Carabiner Testing per ANSI Z359.12:

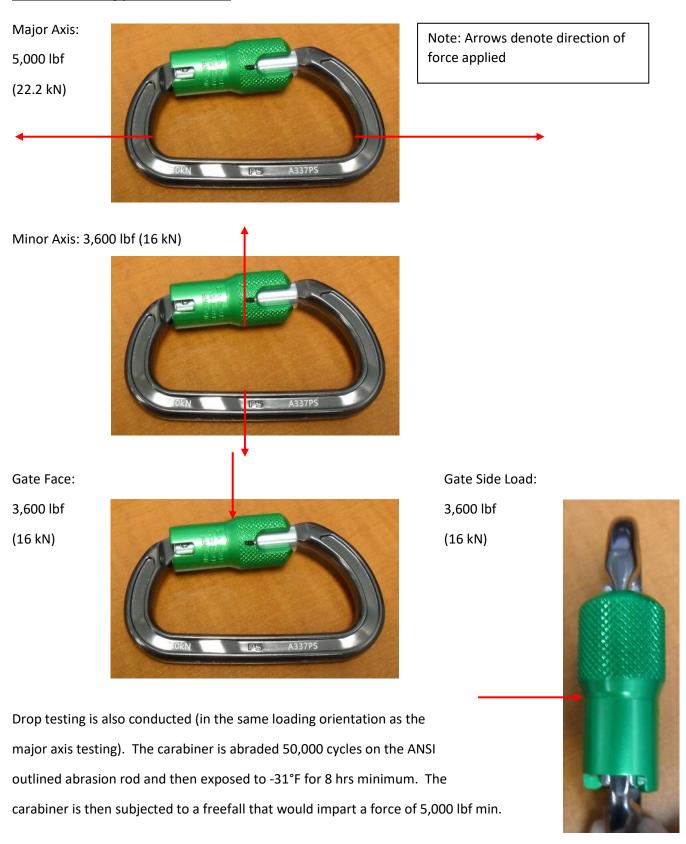
*Note: The illustrations below depict what is required markings by ANSI Z359.12 for the gate in green and markings that have no relevance to ANSI are circled in red. The 9kn marking was added by the manufacturer referring to the strength of the housing with the barrel gate open. ANSI does not require this marking nor does it require a performance test to 9kn with the gate open. The 9kn marking has been removed on new approved carabiners going forward
